Re: Second Submission Review – Green Valley Ranch East Site Plan No. 15 - Site Plan and Plat

Application Number: **DA-1662-26**

Case Number(s): 2022-4014-00; 2022-3019-00

GREEN VALLEY RANCH EAST SITE PLAN #15

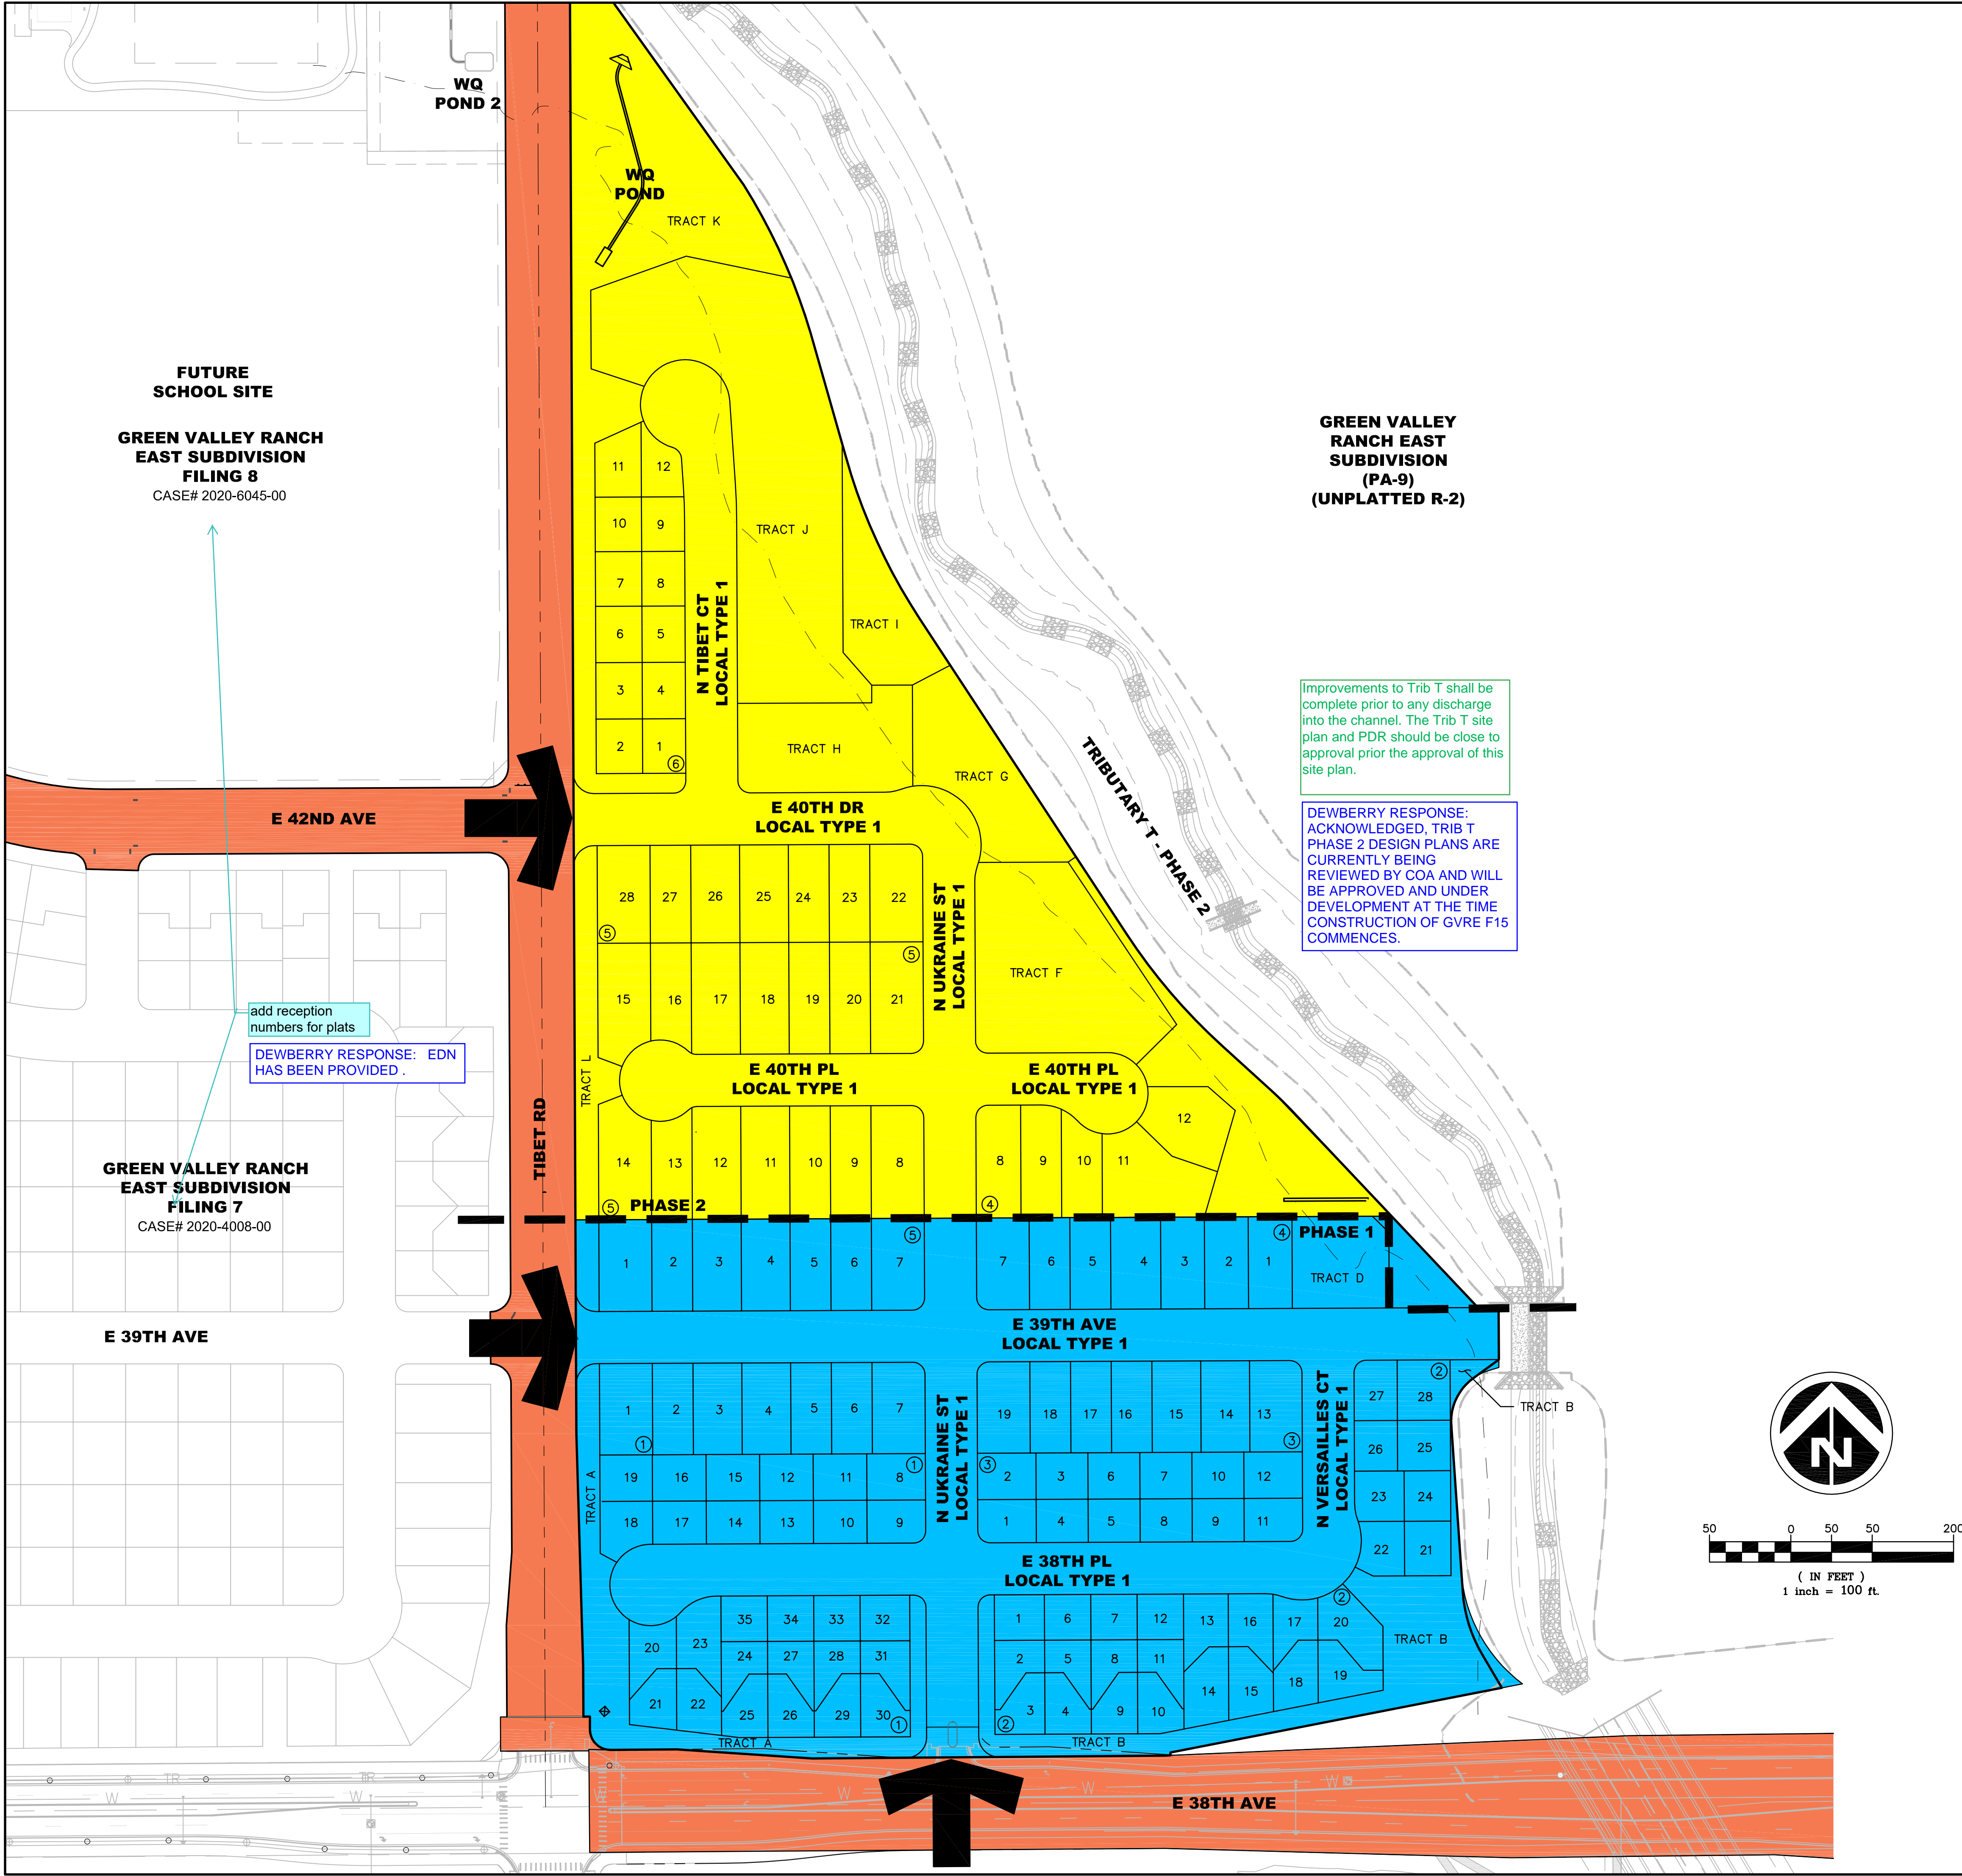
Improvements to Trib T shall be complete prior to any discharge into the channel. The Trib T site plan and PDR should be close to approval prior the approval of this site plan.

add reception
numbers for plats

DEWBERRY RESPONSE:
ACKNOWLEDGED, TRIB T
PHASE 2 DESIGN PLANS ARE
CURRENTLY BEING
REVIEWED BY COA AND WILL
BE APPROVED AND UNDER
DEVELOPMENT AT THE TIME
CONSTRUCTION OF GVRE F15
COMMENCES.

DEWBERRY RESPONSE: EDN
HAS BEEN PROVIDED.

TYPICAL CARRIAGE HOUSE EASEMENTS

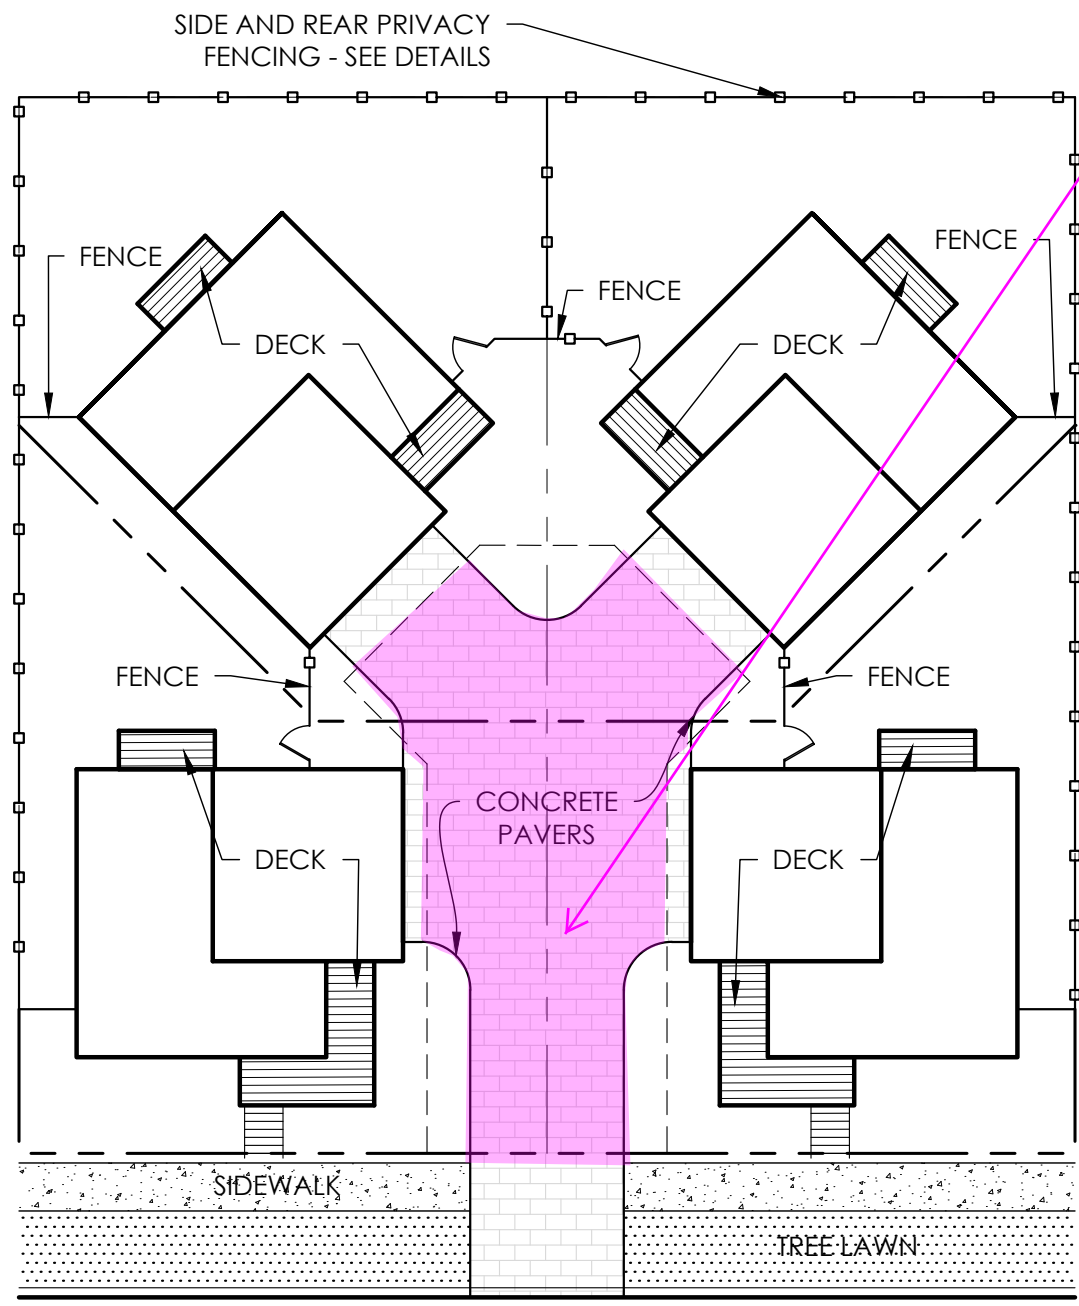
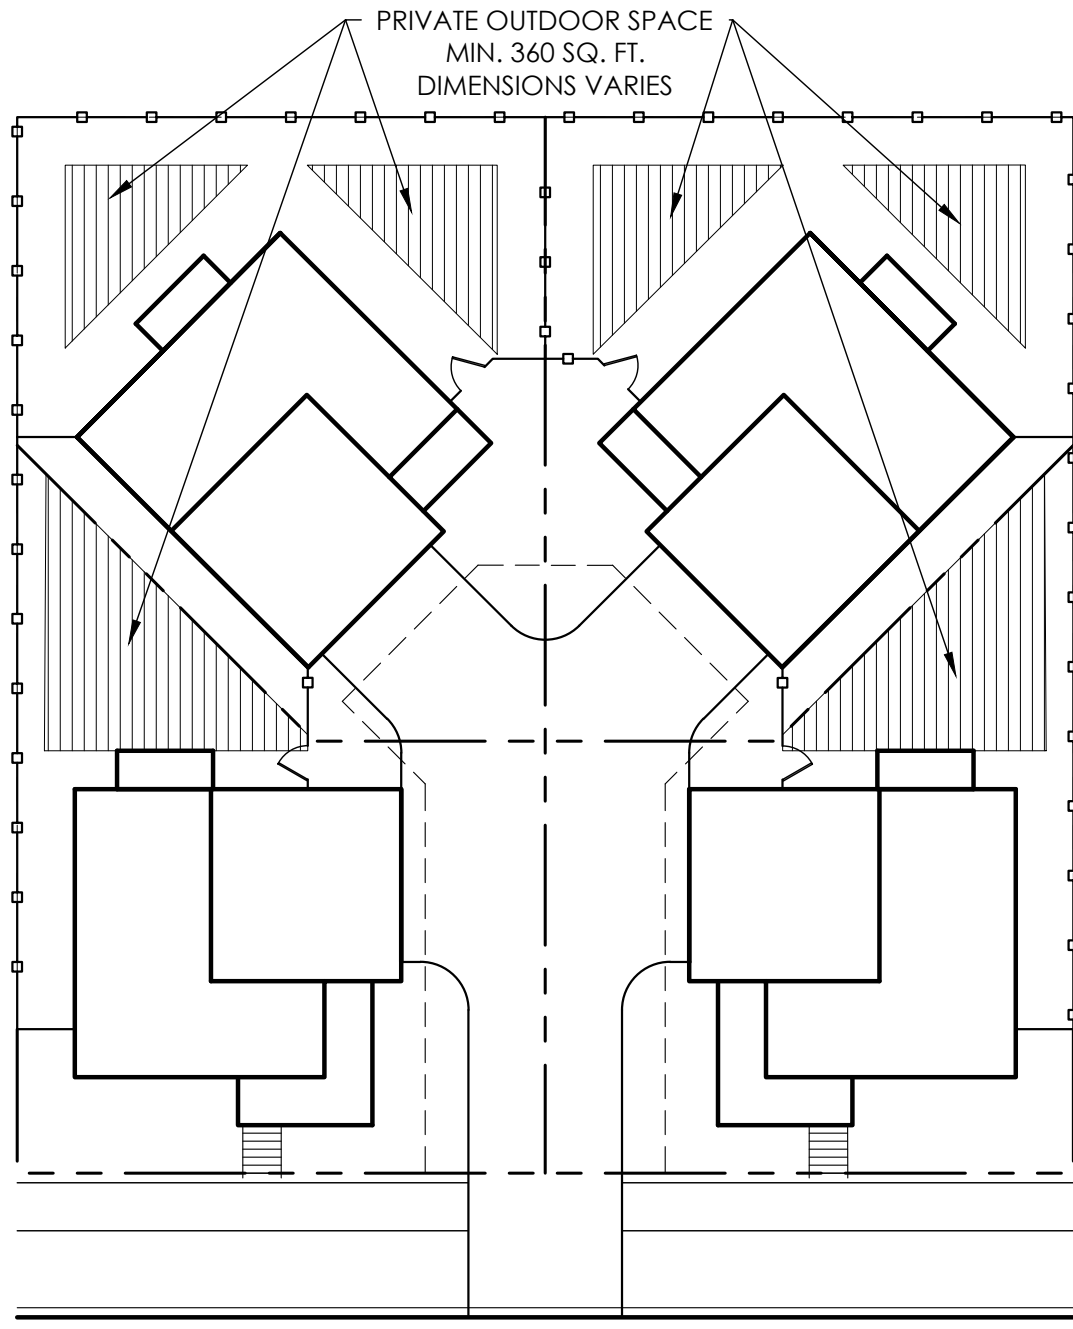
Add a note that the paver shall be owned and maintained by the Metro District including the pavers outside of the easements.

May require license agreement for pavers within easement? (Typical)

TYPICAL CARRIAGE HOUSE EASEMENTS

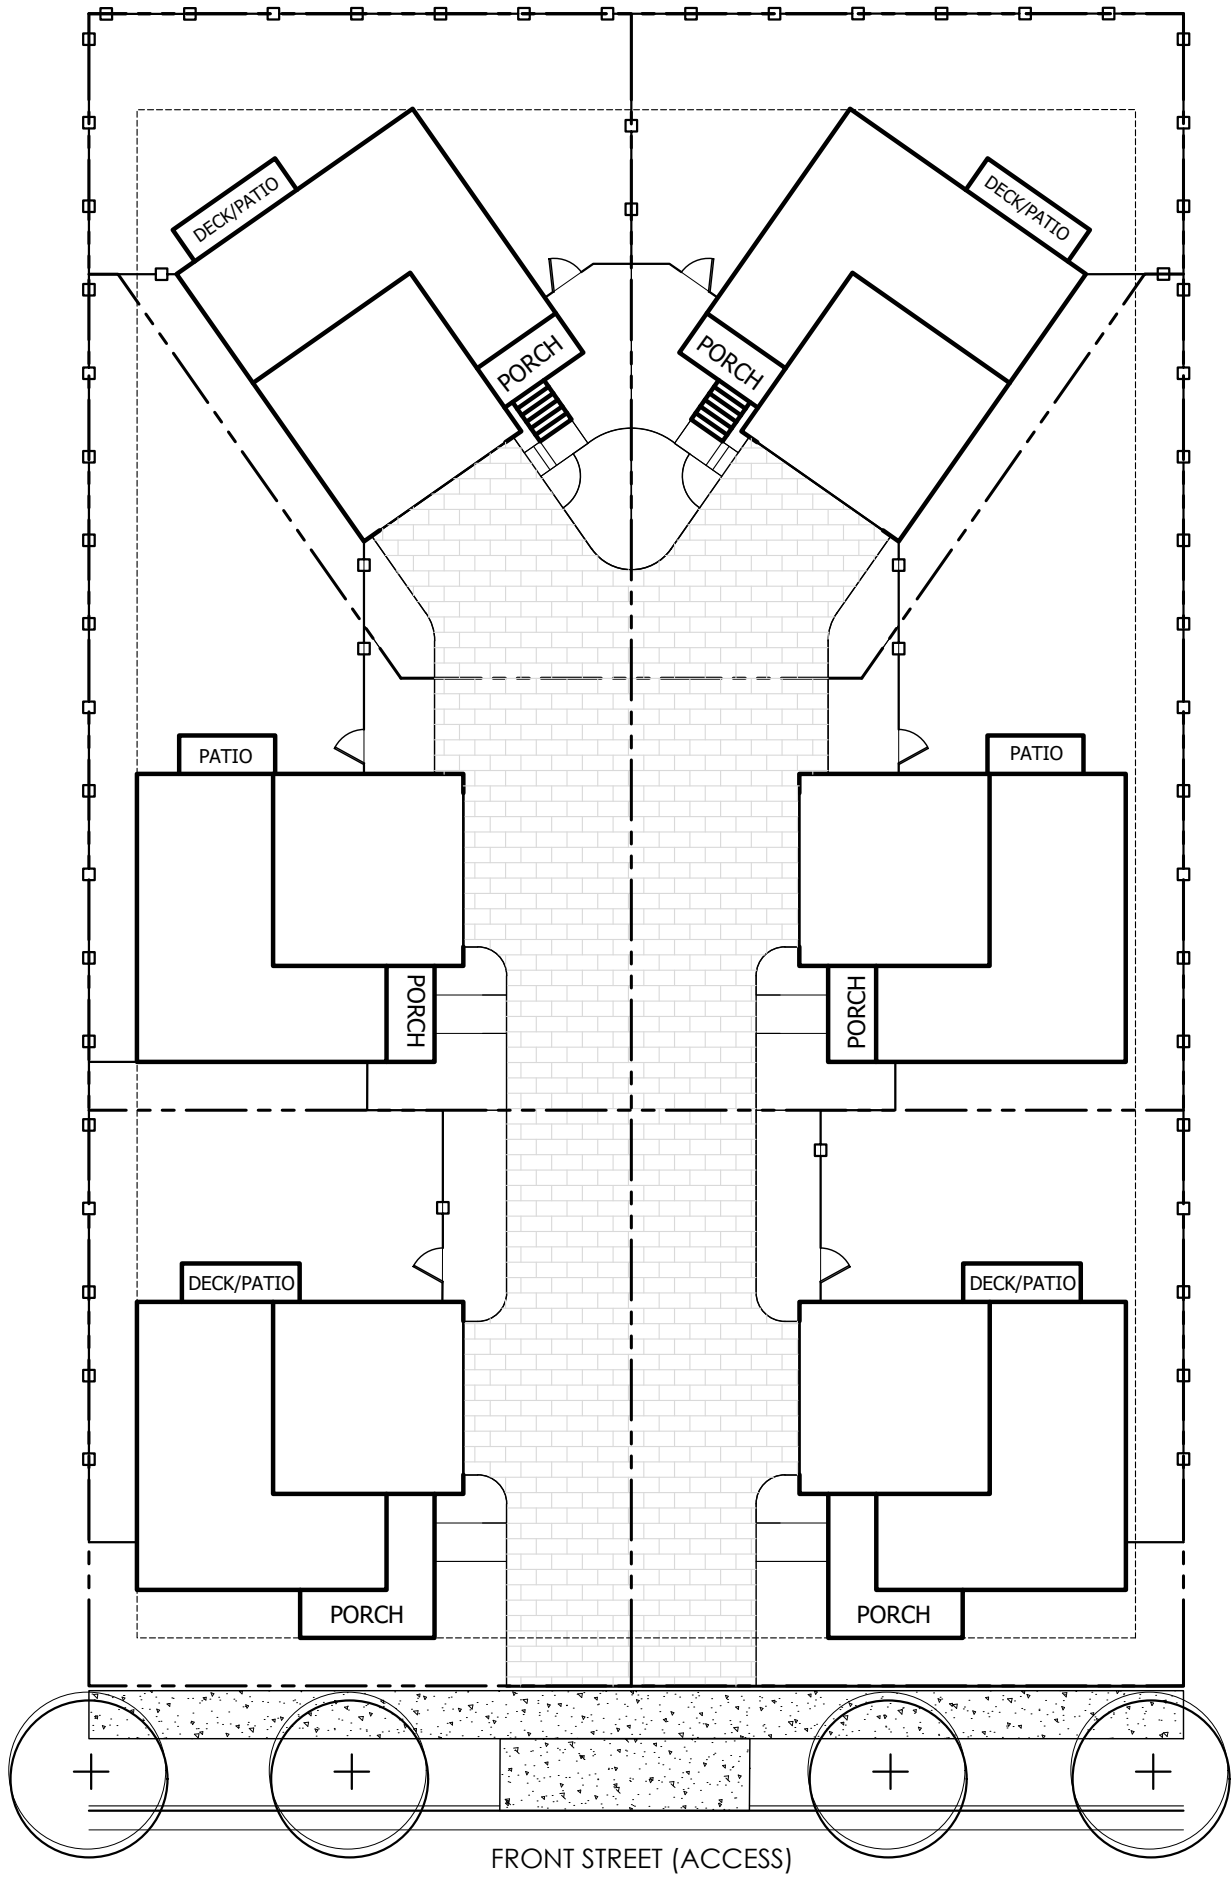
Water services must not be run through the garage floor slabs.
